IDA PAPER P-3016

INDEPENDENT REVIEW OF THE DEVELOPMENT RISKS ASSOCIATED WITH THE COMANCHE ARMED RECONNAISSANCE HELICOPTER

August 1994

This paper reports the results of an independent assessment of the risks associated with the Army's proposed plan to streamline development of the new RAH-66 COMANCHE armed reconnaissance helicopter. The assessment was conducted by a panel of outside experts assisted by senior research staff from the Institute for Defense Analyses. Mr. Pete Adolph served as Chairman of the Panel. Dr. L. Dean Simmons was the IDA Project Leader for the task. The other outside members of the panel included Mr. Dick Ballard, Professor Alfred Gessow, Mr. Lou Herrick, Mr. Matt McGuire, and Mr. Nic Torelli. Other IDA participants included Mr. Lucien Biberman, Mr. Bill Brykczynski, and Dr. David Sparrow. The review was carried out between June 28, 1994 when the panel first convened and August 29, 1994 when the results were presented to the cognizant officials within the Office of the Secretary of Defense.

EXISTING CONTRACTED DEVELOPMENT PROGRAM

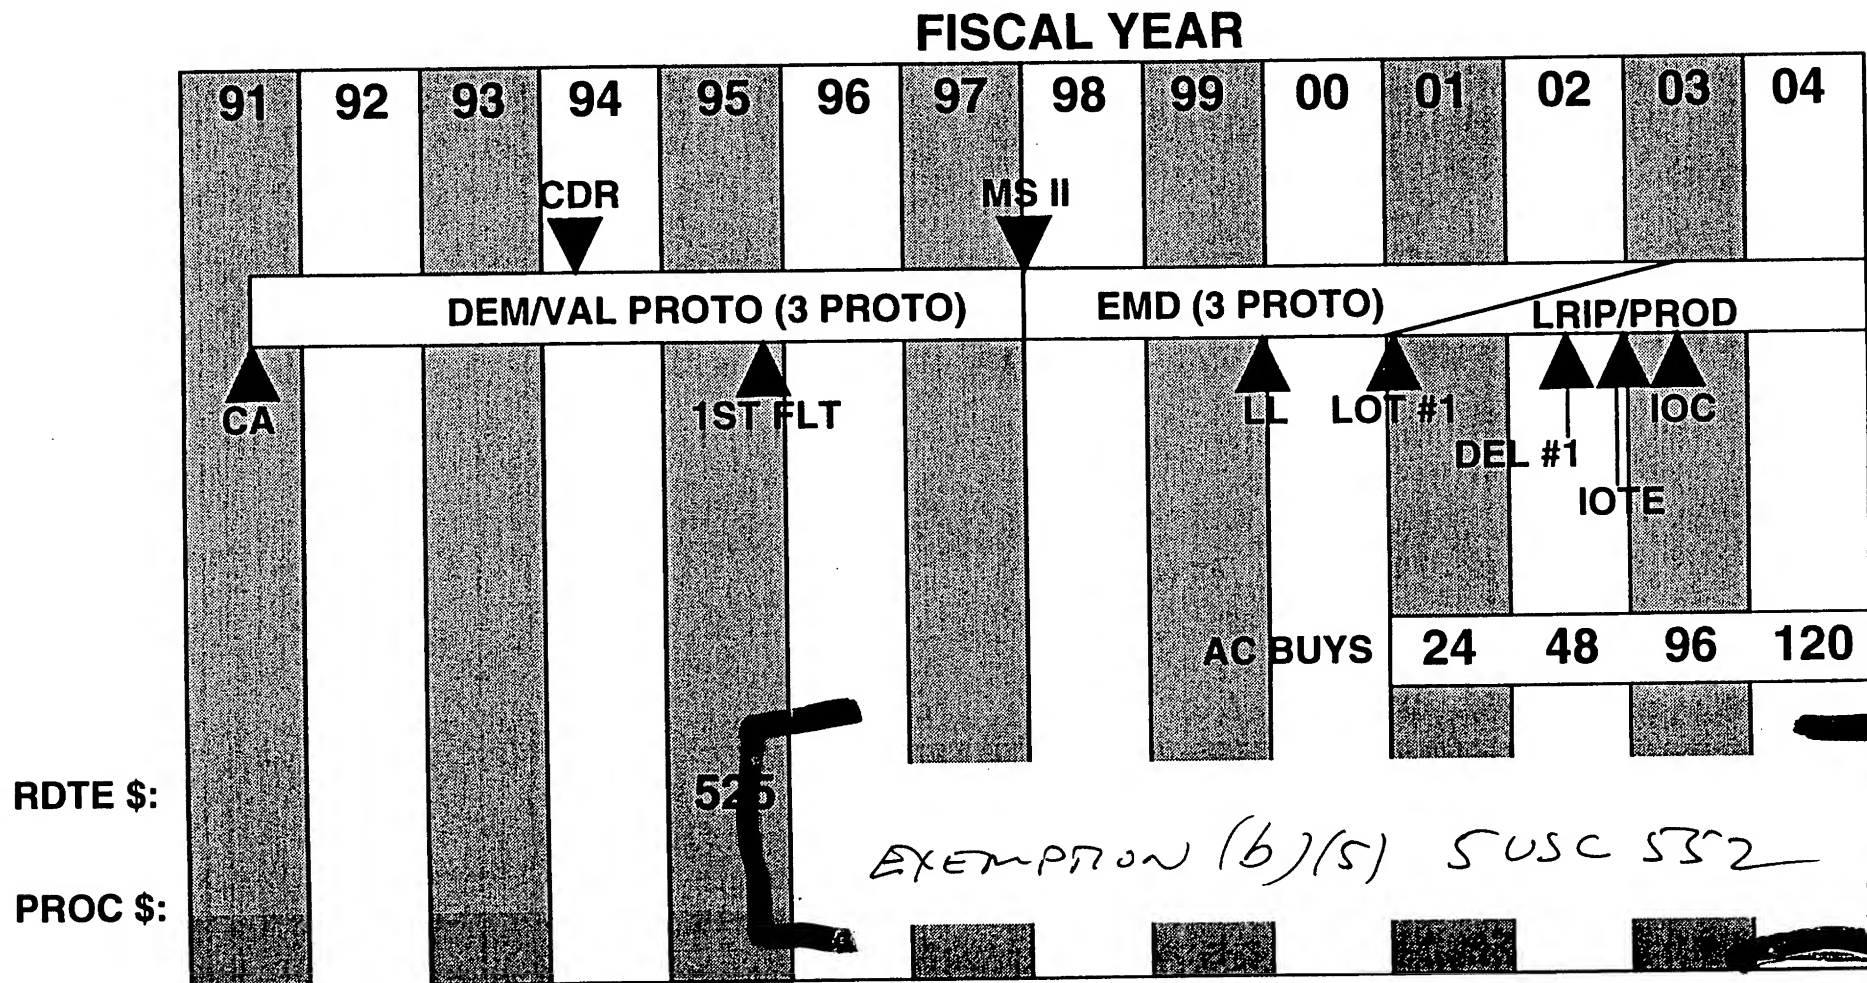
This chart shows the schedule and funding profile for the existing, contracted COMANCHE development program. Actually, only the DEM/VAL phase is currently under contract. If this development plan were continued, the Army's COMANCHE Program Office and the Boeing-Sikorsky Joint Program would soon need to begin negotiating a contract for the EMD phase of development.

As indicated on the schedule, this program features three prototype aircraft built and tested during the DEM/VAL phase, with first flight of the first COMANCHE prototype scheduled for November 1995. Three additional prototypes would be built and tested during the EMD phase. At the conclusion of DEM/VAL and prior to the award of the EMD contract, a Milestone II review would be held for the program. Long-lead production would begin at the end of FY 1999 and the first 24 production aircraft would be funded in FY 2001. Plans call for production to ramp up to 48 in FY 2002, to 96 in FY 2003, and to the full production rate of 120 per year by FY 2004. The first production aircraft would be delivered to the Army in mid FY 2002. The Initial Operational Test and Evaluation (IOTE) would be held early in FY 2003. Initial Operating Capability would be achieved by mid FY 2003.

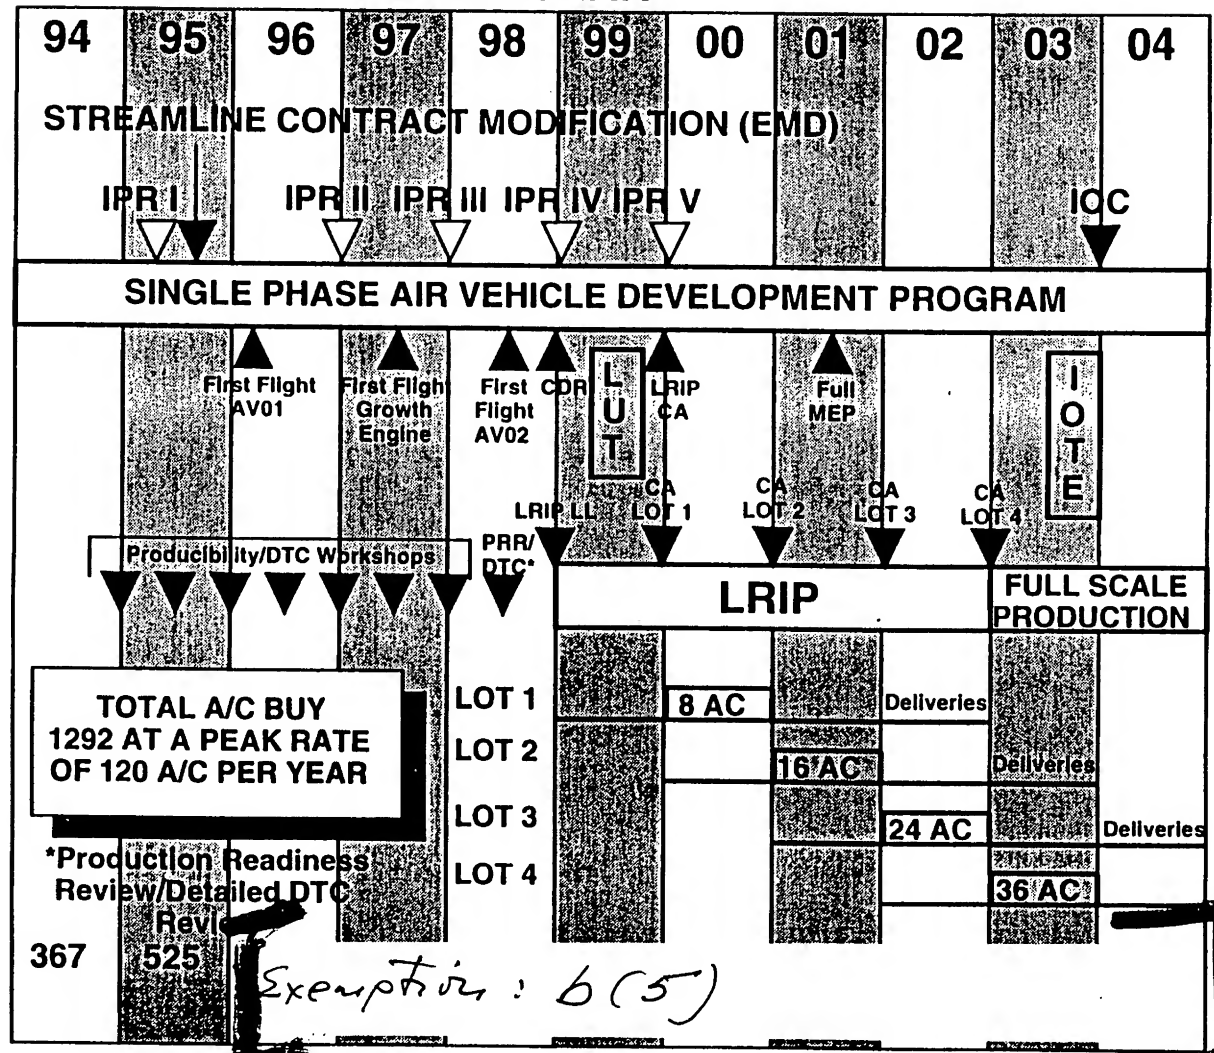
The schedule for the "streamlined" development program proposed by the Army is shown on this chart. Under this plan, in May 1995 the Army would modify the existing COMANCHE development contract to incorporate the activities normally conducted during EMD into a new single-phase development program. The first flight of the first of two DEM/VAL prototypes would occur in early FY 1996, several months later than was proposed under the existing development contract. The first flight of the second DEM/VAL prototype would not occur until late FY 1998, nearly 2 1/2 years after the first flight of the first prototype. The next three prototypes would be taken from the first lot of eight Low-Rate Initial Production (LRIP) aircraft. These prototypes would be delivered to the Army during FY 2002.

In comparison to the Army's previous plan for COMANCHE development, the "streamlined" plan initiates production one year earlier, but at a significantly slower rate. In the first year (FY 2000), only 8 aircraft would be built; in the second, 16 aircraft; in the third, 24 aircraft; and in the fourth (FY 2003), 36 aircraft.

OSD oversight for this program would be accomplished through a series of In-Process Reviews (IPRs), the first of which would occur early in FY 1995 prior to the award of the modified development contract. Beginning at the end of FY 1996, in-process reviews would

Finally, as indicated on the chart, the funding profile for the proposed "streamlined" program is the same as is currently planned for the existing program.

REVISED STREAMLINED PROGRAM

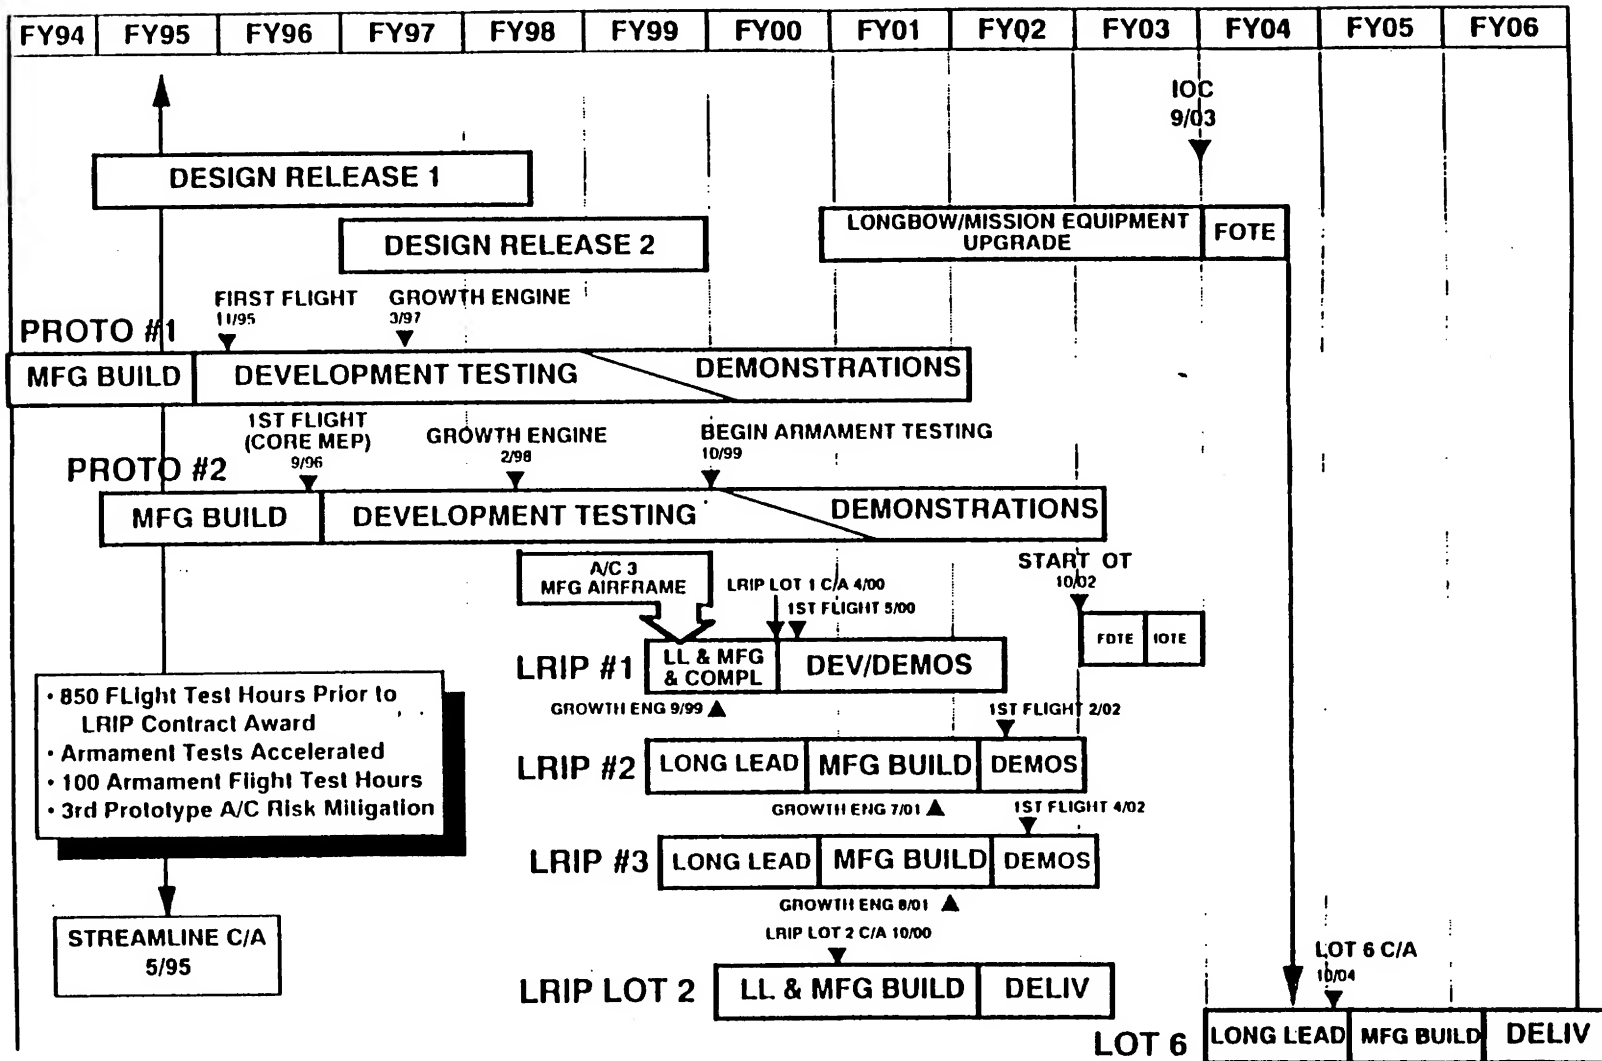
Following the submission of its original "streamlined" proposal, the Army's COMANCHE Program Office significantly revised its approach, in large part to remedy deficiencies identified during the OSD review of the plan as well as objections raised in other critiques, including that of this panel. This chart shows the revised "streamlined" program as briefed to the review panel on August 18, 1994. Relative to the initial "streamlined" approach, the revised approach features a number of significant changes of which the principal alterations are summarized on the next two charts.
